Human Factors Evaluation of the Tank, Combat
Full Tracked: 105mm Gun, M60

Consulting Report
February 1961

A report of work done in connection with Subtask VIII, FIREPOWER, Task 11-26,
"Methods for Improving Performance in Tank Gunnery"

Figure 18:

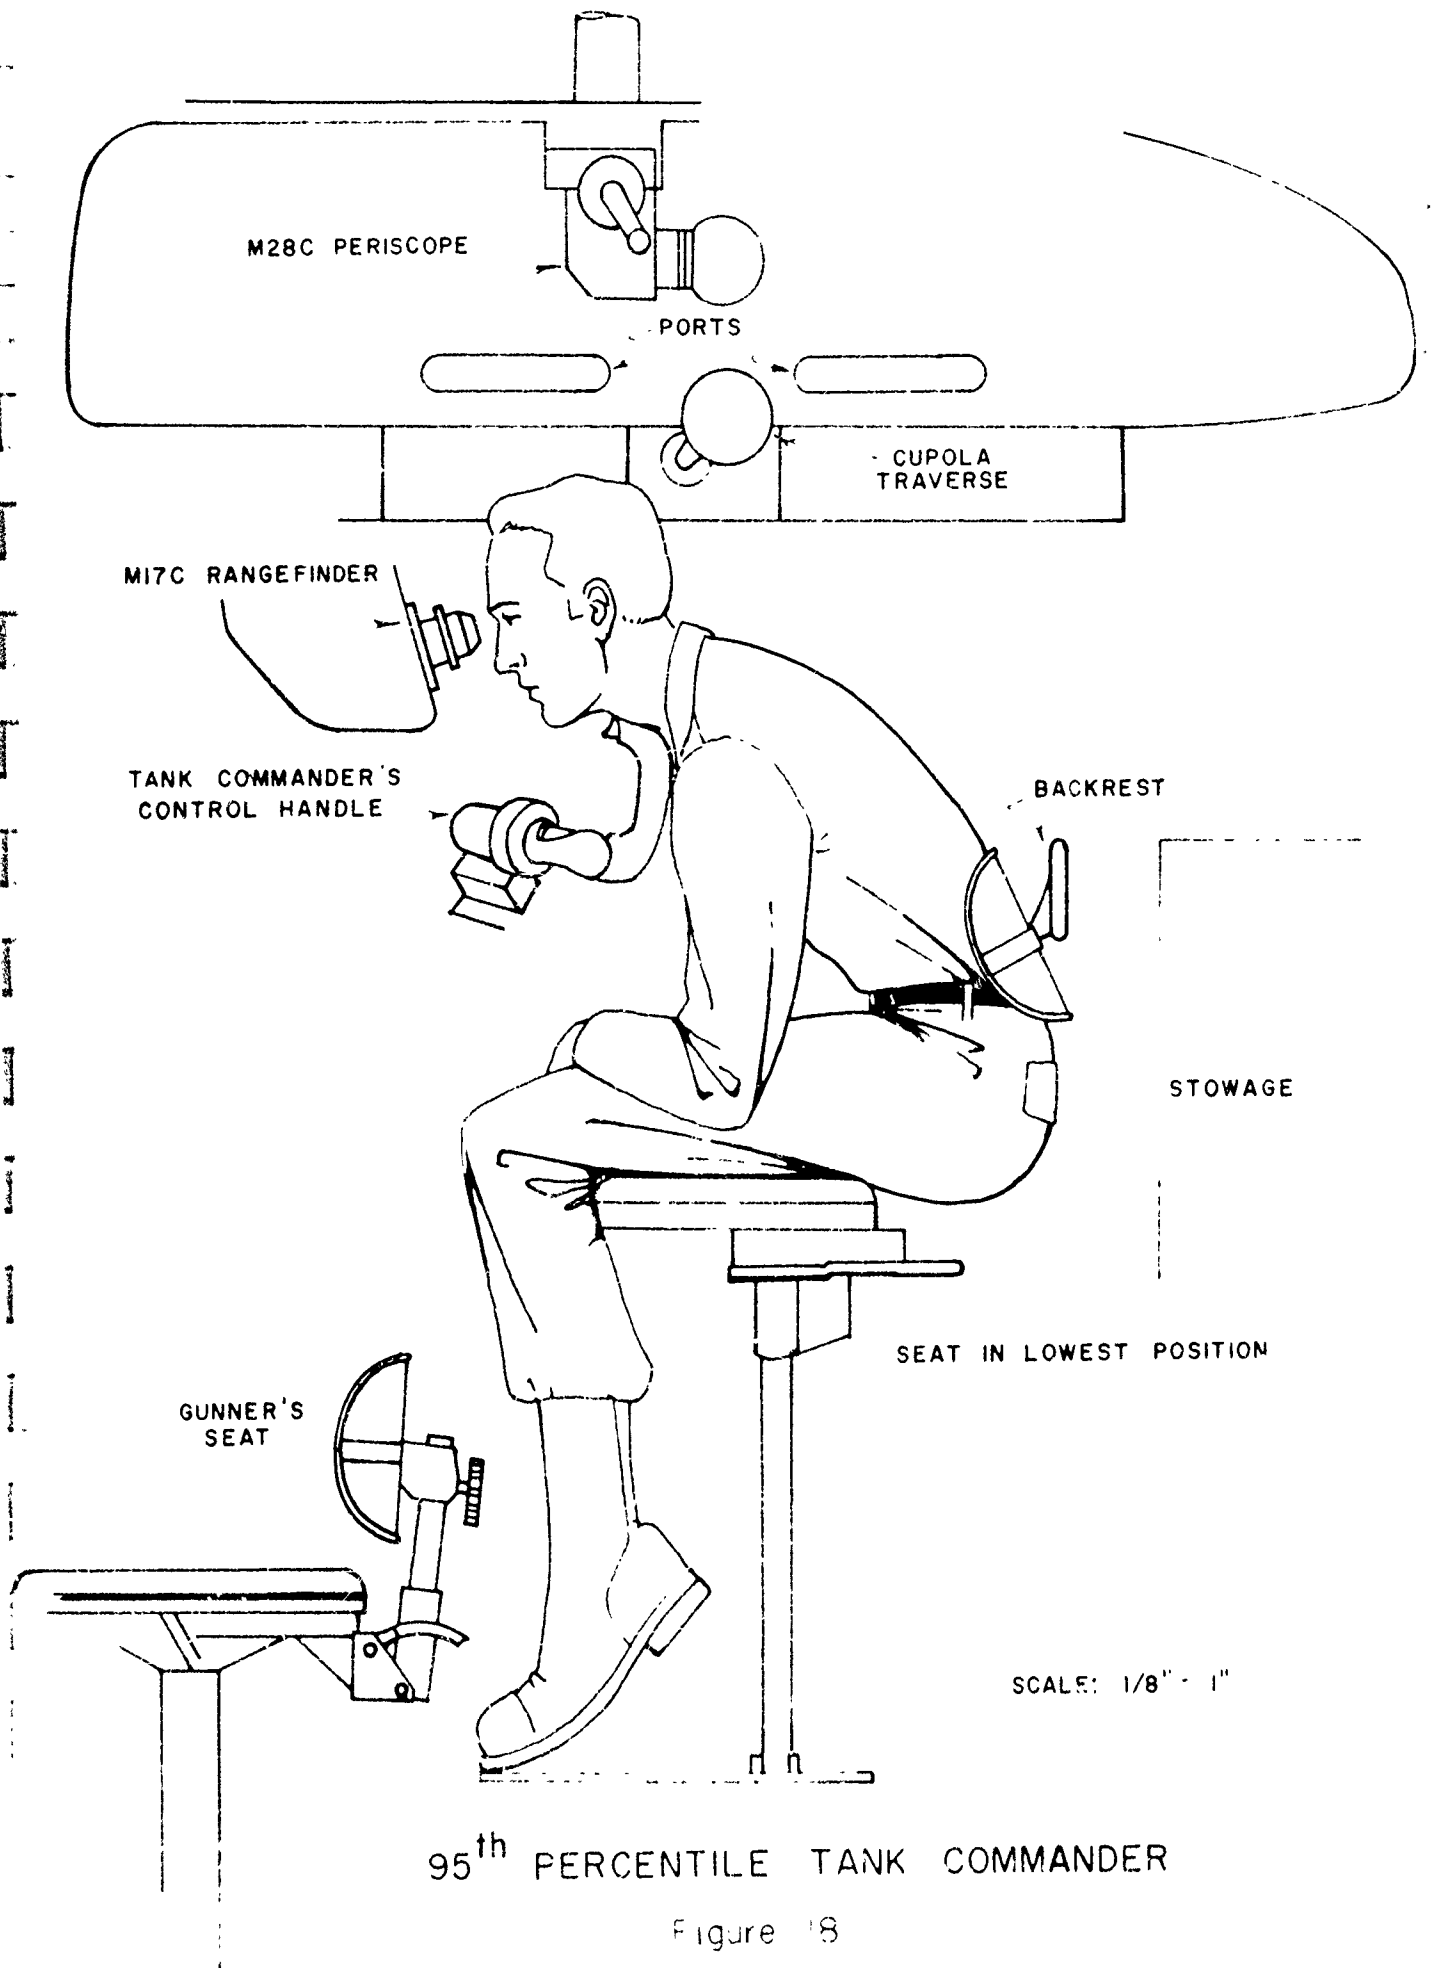
The commander's platform is of little help. It is 24.5 inches below the seat so that only the man's toes touch it. (See Figure 18.) At its highest

Figure 21:

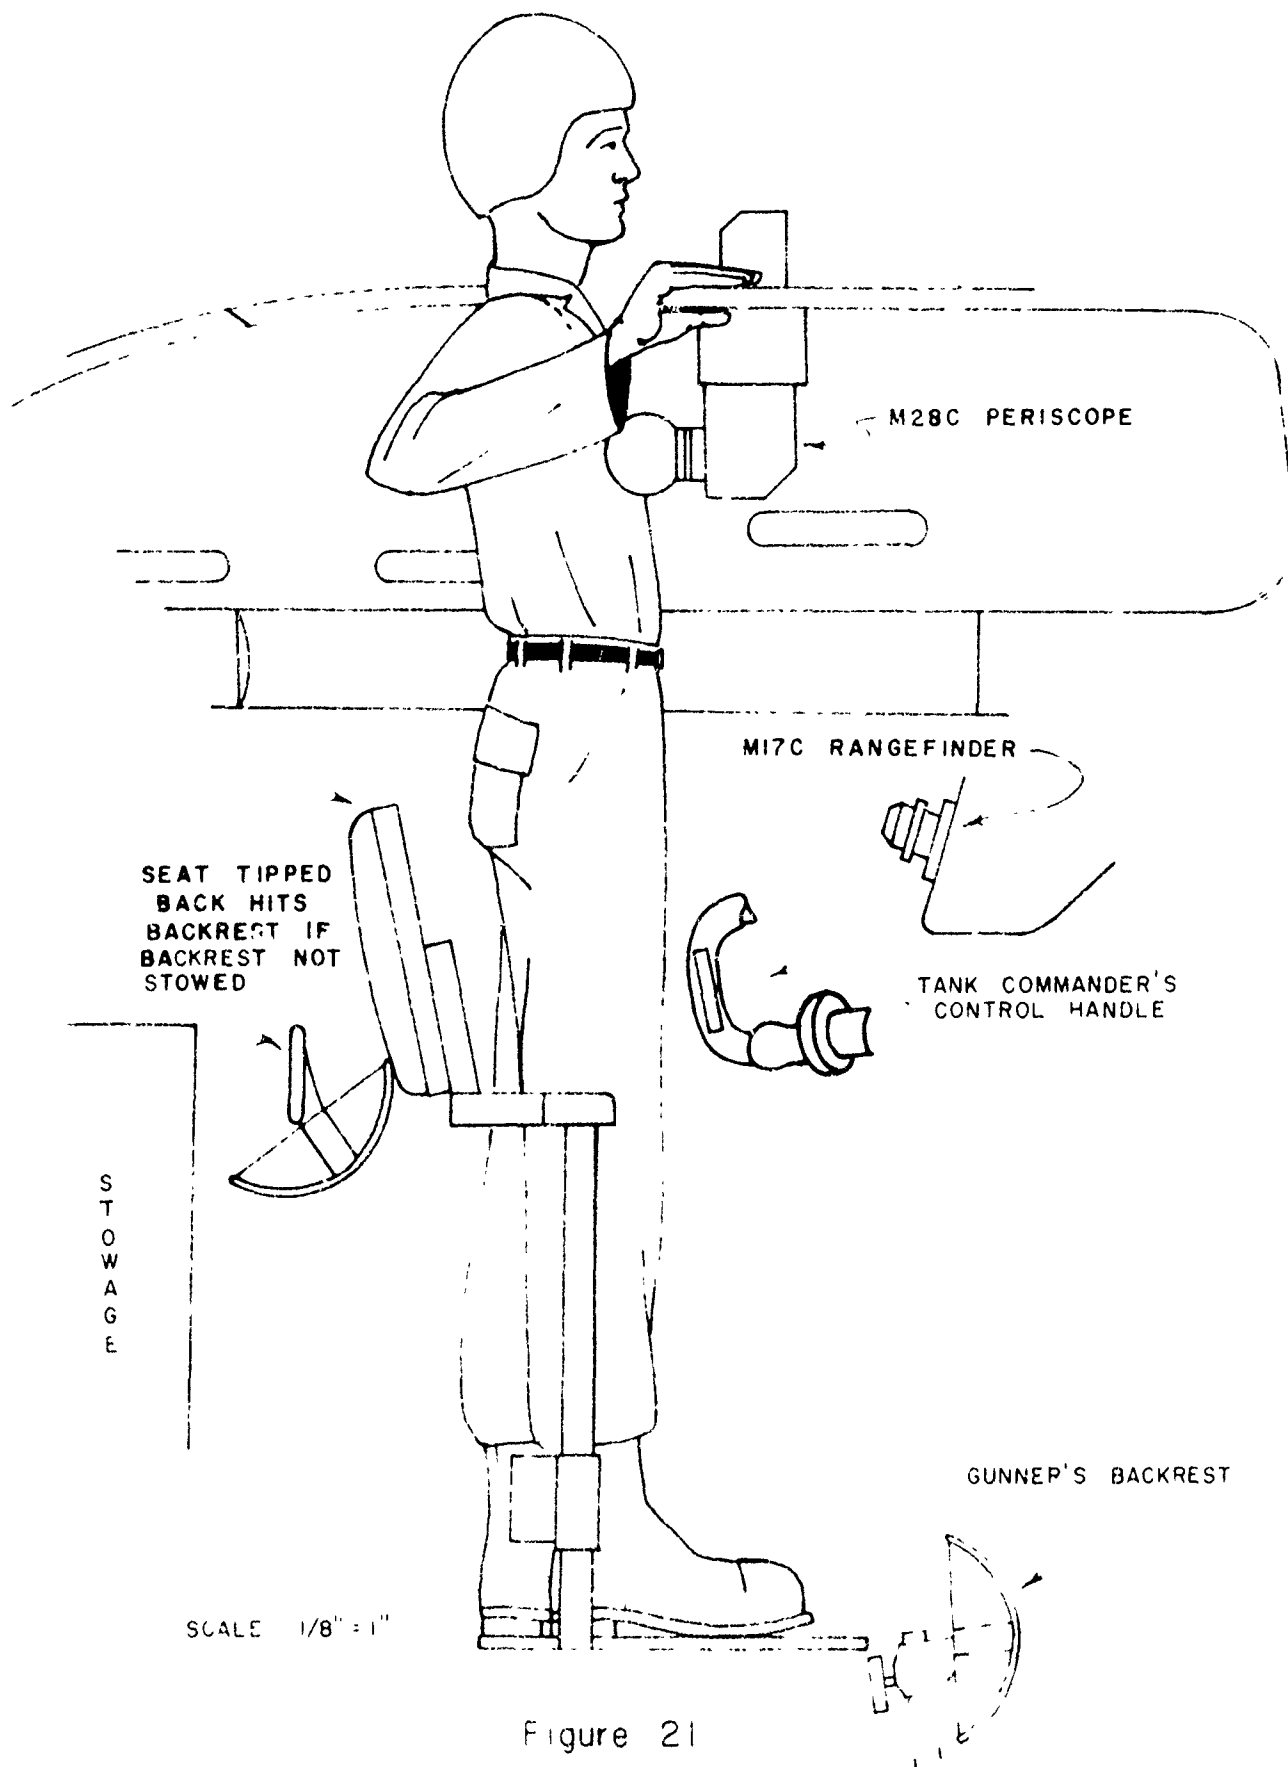
position, the commander can barely see over the top of the cupola and cannot see terrain close enough to the front of the tank to aid the driver during night operation. (See Figure 21.) It is therefore recommended that the platform be moved to 16 - 18 inches below the seat; at this distance the platform would provide support for the feet. Also the added six to eight inches in maximum height would aid the commander during operation with the hatch open.

The commander's backrest is of little use; in its present position it provides support only during range finder operation. When he is using the cupola periscope it is far behind the commander's back; so that it tilts forward, and could cause serious back injury during firing. (See Figure 23.) During operation with the hatch open and the commander's head out, the backrest is too low to provide support. (See Figure 20.) Furthermore, the backrest must be placed in a stowed position whenever the commander wishes to raise the seat level or fold up the seat. (See Figure 21.)

Interference of Seat Handle When
Commander Stands on Platform

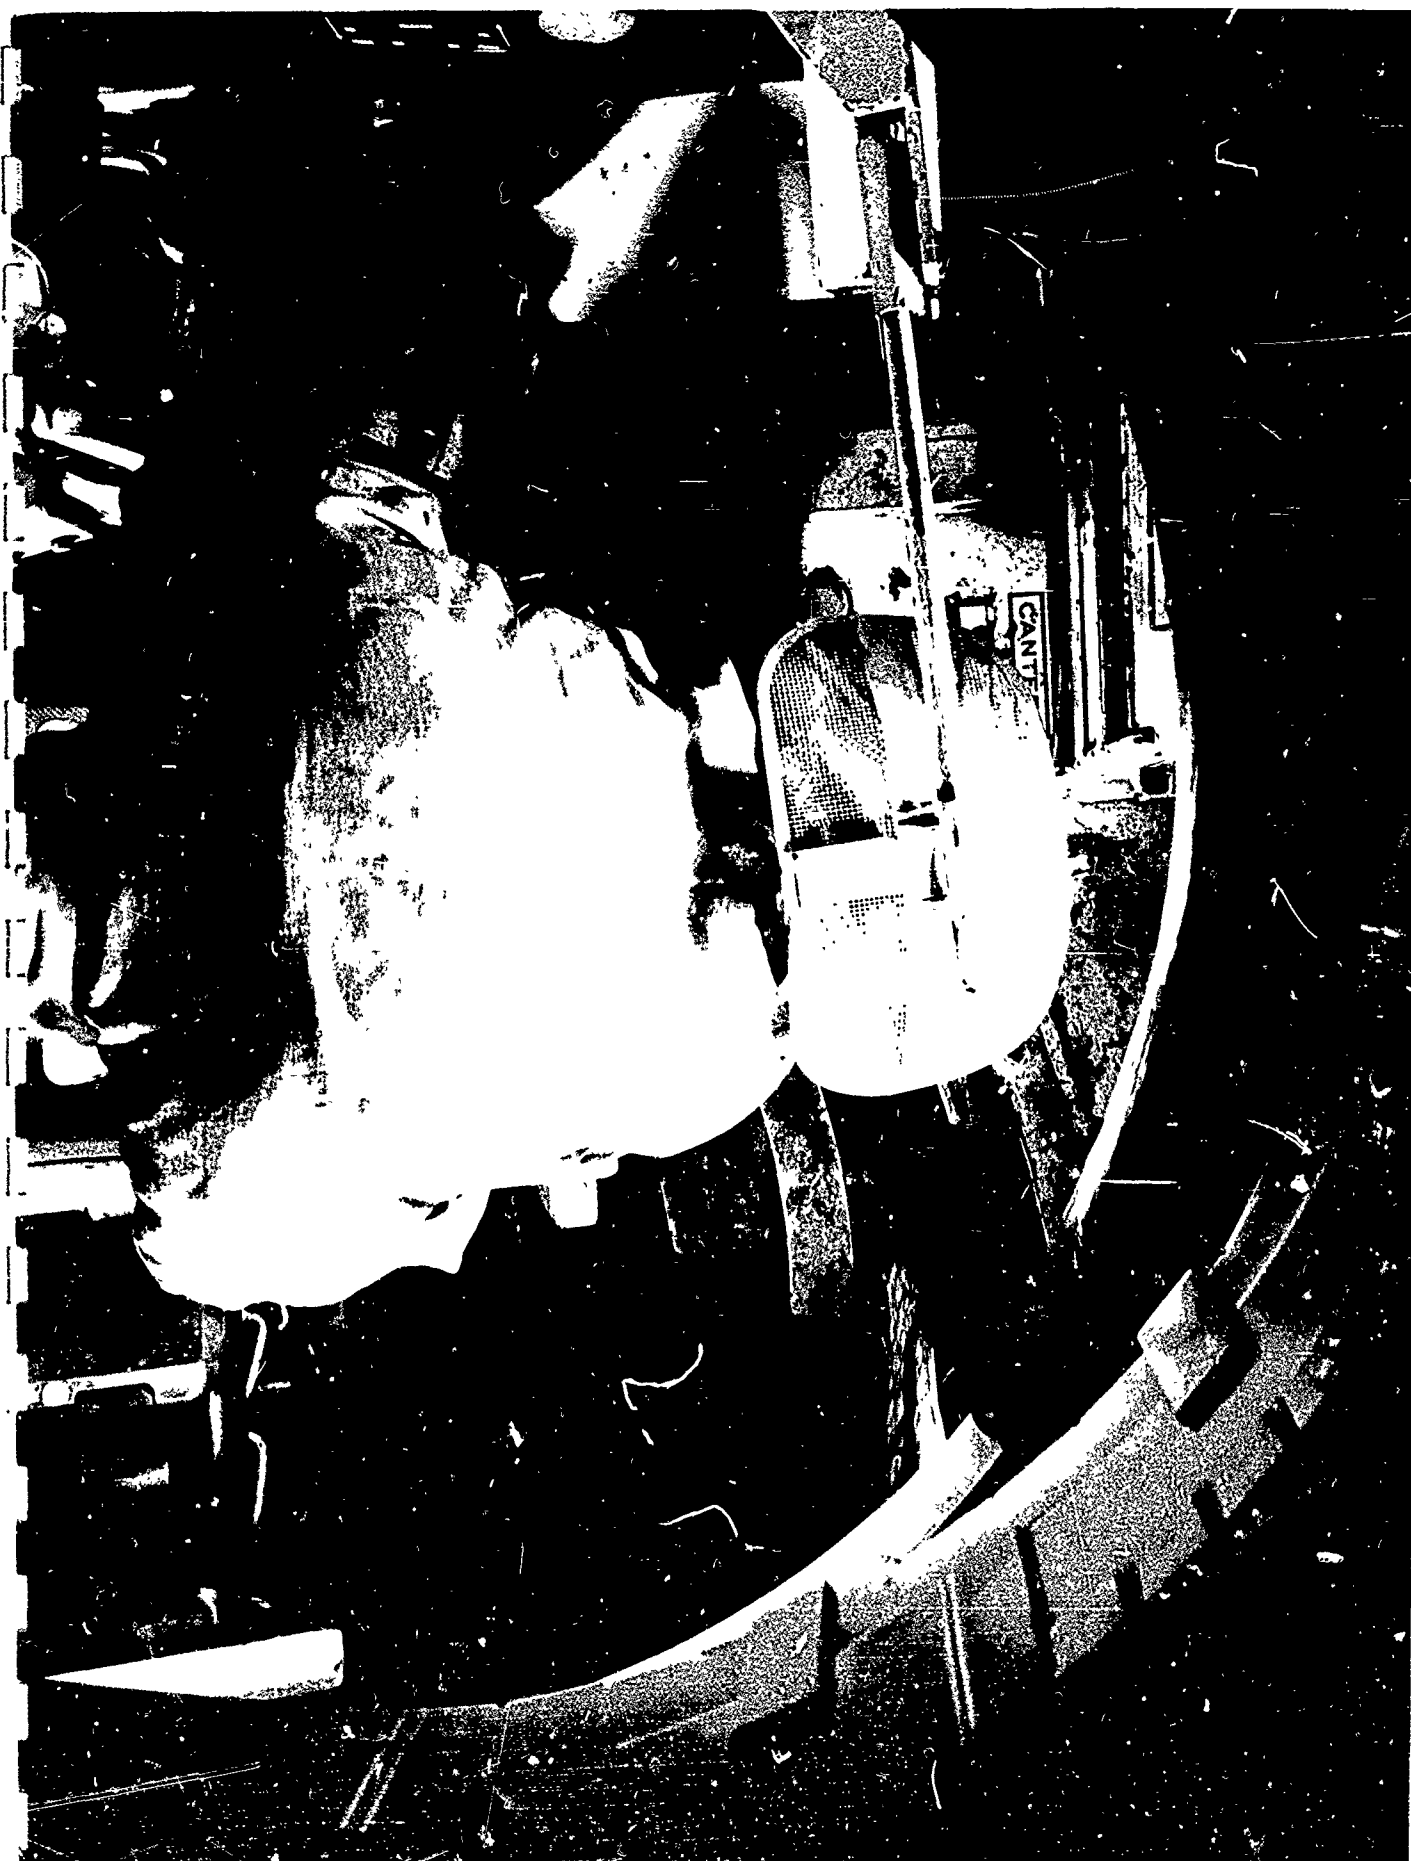
The adjustment mechanism for the seat assembly is very difficult to operate, and the seat handle interferes with standing on the platform. (See Figure 22.) The commander must be off of the seat and platform before they can be raised, and should be off of them when they are lowered. Furthermore, the locking pin does not insert securely; it is apt to release when the commander's weight is applied to it. Again, supports for the seat and platform are not sturdy enough to withstand the force applied over rough terrain. Both seat and platform are likely to be bent down. It is therefore recommended that a method be devised to raise and lower the seat assembly while the commander is on it, that the assembly be rugged enough to withstand the forces exerted during cross-country operation, and that there be a means of locking it safely in position.
